Subject: NOISE FROM FRONT DOOR CHECKER AREA	Bulletin No: 09-012/13
	Last Issued: 04/29/2013

2013-2014 CX-5

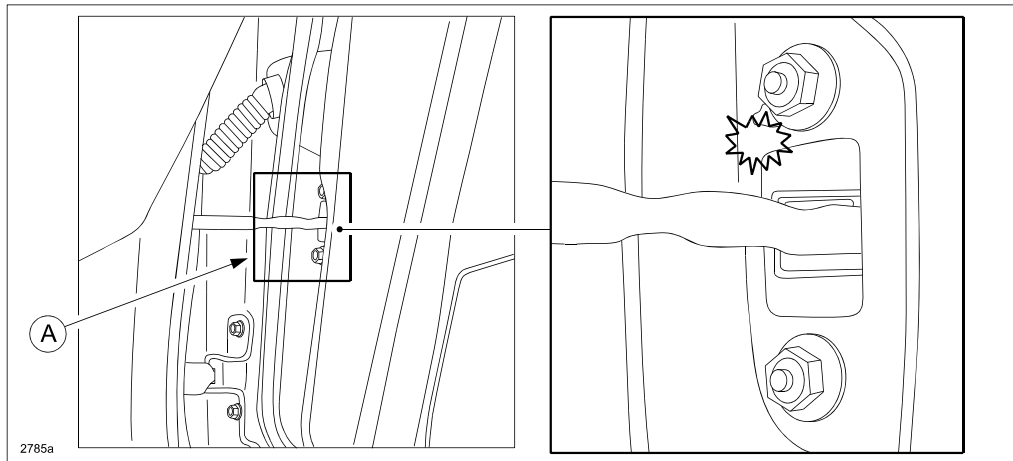
Some vehicles may experience noise from the front door checker installation location (A) whenever the door is opened. When the door is fully opened, the door checker may become over-stroked and cause a crack at the spot welding area around the door checker.

REPAIR PROCEDURE

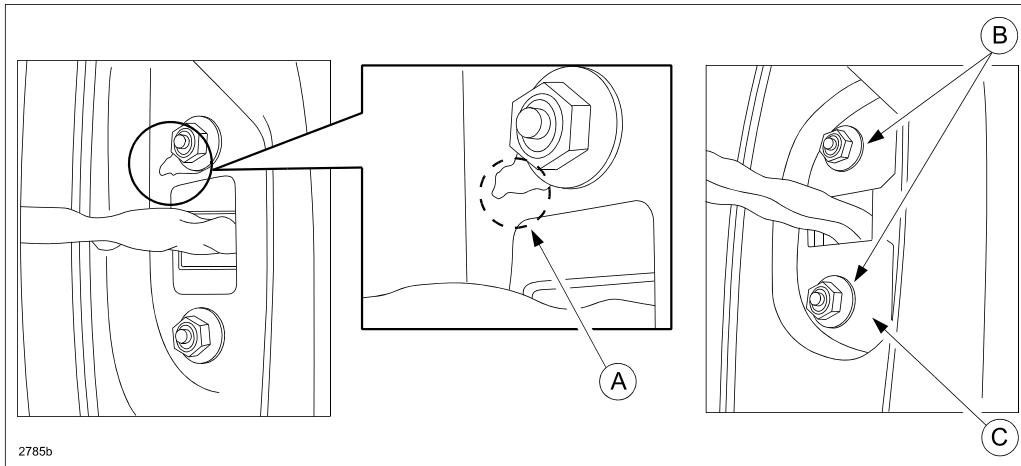
1. Verify the customer concern.
2. Inspect the body panel welding point (A) on both front doors.
 - If no cracks are found on the body panel, this service bulletin does not apply. Refer to the online instructions on MS3 or the Workshop Manual (Section 09 - Body and Accessories) for further troubleshooting.
 - If the body panel is cracked, repair it according to the steps below:

- a. Apply approx. 0.3 ml grease per side (using either molybdenum grease or lithium grease) on the welding point (A) (cracked area).
- b. Install plate (C) (checker reinforcement) on the body panel.
Tightening Torque (B): 71-106 in•lbf {8-12 N•m, 82-122 kgf•cm}
- c. Repeat the repair on opposite side front door.

- a. Remove all corrosion found on the body panel.
- b. Apply primer to the repaired surface.
- c. Apply touch up paint to the repaired surface.
- d. Install plate (C) (checker reinforcement) on the body panel.
Tightening Torque (B): 71-106 in•lbf {8-12 N•m, 82-122 kgf•cm}
- e. Repeat the repair on opposite side front door.
